Serial No.: 09/762,223
Filing Date: May 7, 2001
Applicant(s): ANSON et al.
Title: DEVICES AND METHODS FOR THE REPAIR OF ARTERIES

**REQUEST FOR REINSTATEMENT OF PATENT
APPLICATION PRESUMED ABANDONED BY USPTO
(37 CFR §1.8(b))**

**COMBINED PETITION UNDER 37 CFR §1.181(a)(1)
TO WITHDRAW PREMATURE FINAL REJECTION /
TO WITHDRAW HOLDING OF ABANDONMENT
(37 CFR §1.113(a); MPEP 706.07(c))**

Figure 10

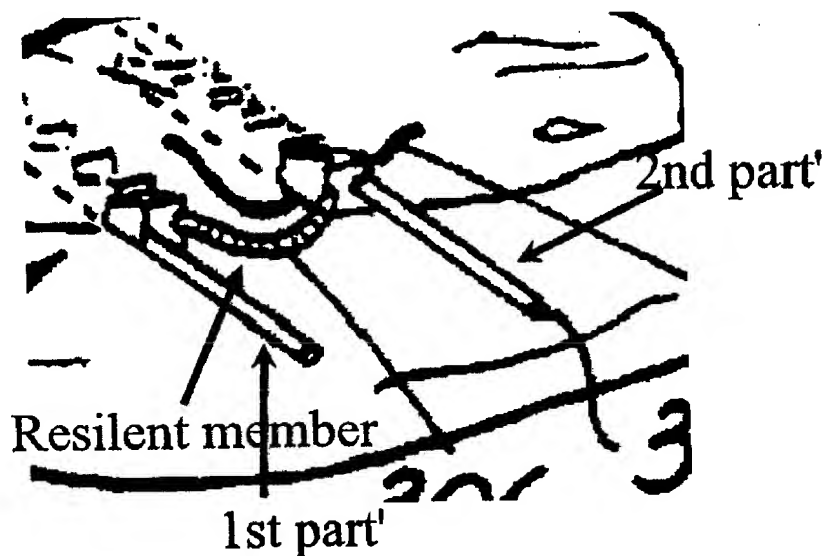
14. The applicant describes a helical structure in part C, yet there is no mention of a helical structure in the specification and no support in the diagrams to substantiate the claimed subject matter.

The stabiliser (Fig. 10) consists of two elastically deformable thin strips of metal (47) which, when unconstrained form a nominally circular shape (46). The two strips are riveted together (45) at the leading edge and are riveted onto a short metal tube (49) which has been arranged to retract within a catheter sheath (48). **The metal tube (49) serves as a locating member for locating the device with respect to a catheter, and the distal portions of the strips (46) define support members (320) for supporting the catheter on the inner wall of an artery or graft. The proximal portions of the strips (46) then serve as resilient members (322) which connect the locating member (49) and the support members (320), with the resilient members (322) biasing the support members (320) toward the artery wall. As the resilient members (322) bias the support members (320) toward the artery wall, they reduce the distance between the end of each support member (322) and its resilient member (322), thereby causing the support member (322) to bow radially outward with respect to the locating member (49).**

Figure 14

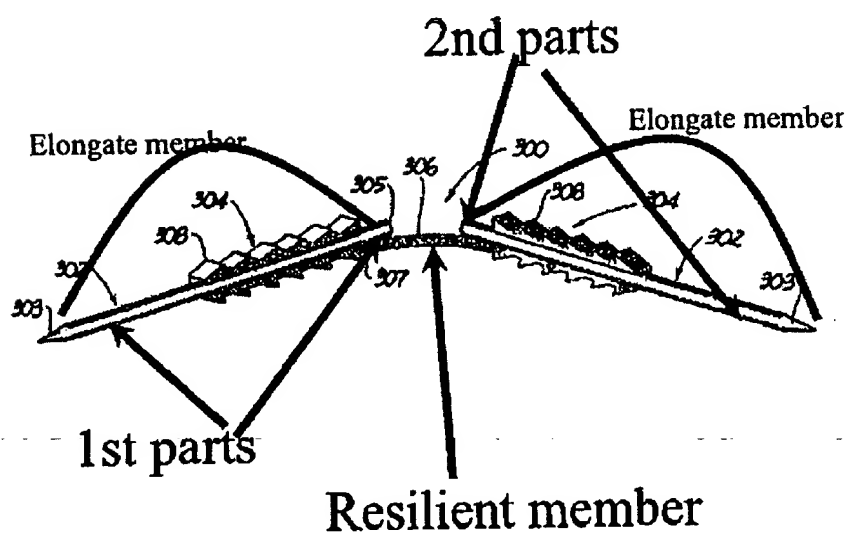
17. Regarding claim 68, the elongate member of the Green device has the capability of being in an open configuration, figure 14, and a retaining configuration, figure 1, where in the 1st and 2nd parts are closely spaced, wherein the device is biased towards the closed configuration.

18. Regarding claim 69, the fixator has 2 parts that are sharpened, allowing it to pierce an artery and a graft (see figure 14).

Reconsideration of the rejections is requested.¹ Initially, note that claim 68 recites elongated members (in the plural). If *Green* is regarded as having a pair of elongated members 302/303/308/304 (as shown in the Examiner's second drawing in the Office Action), *Green* neither discloses nor suggests bending each of the elongated members as recited in claim 68; rather, each elongated member stays straight, with the bioresorbable connection between them (see column 8 line 62 onward) being bent. Note that the Fig. 10 apparatus is shown "spread" merely because the bioresorbable connecting material is not rigid, and that the apparatus is not in fact bent when deployed: as depicted in Figs. 7-9 and described in the specification, the *Green* apparatus is driven forward in a U-shaped form, see Figs. 13 and 14, with each "arm" being in parallel and being driven by needle 302, see Figs. 13 and 15, and the apparatus remains in this configuration when deployed, without the spacing between the arms being varied. After deployment, the bioresorbable connection between the arms dissolves while the arms remain in tissue as retaining spikes (see, e.g., column 10 lines 55-60). Thus, *Green* has no teaching or suggestion that a fixator may include an elongated member (much less multiple elongated members) wherein each elongated member is bent from a linear form to a form wherein its ends are closely spaced, such that each elongated member retains a graft and artery together. *Green* is simply a rather conventional surgical staple having linear arms which remain in linear form when installed in tissue, but the "bridge" of the staple is made of dissolving (and flexible) material. Consider that this flexible material cannot maintain the arms in a closely spaced condition (and in fact it cannot hold the arms in any fixed location owing to its flexibility), and thus there is no way to use the *Green* apparatus to fix an artery and graft in the manner claimed, nor is there any apparent reason why one would be motivated to modify the *Green* apparatus to provide this capability. In
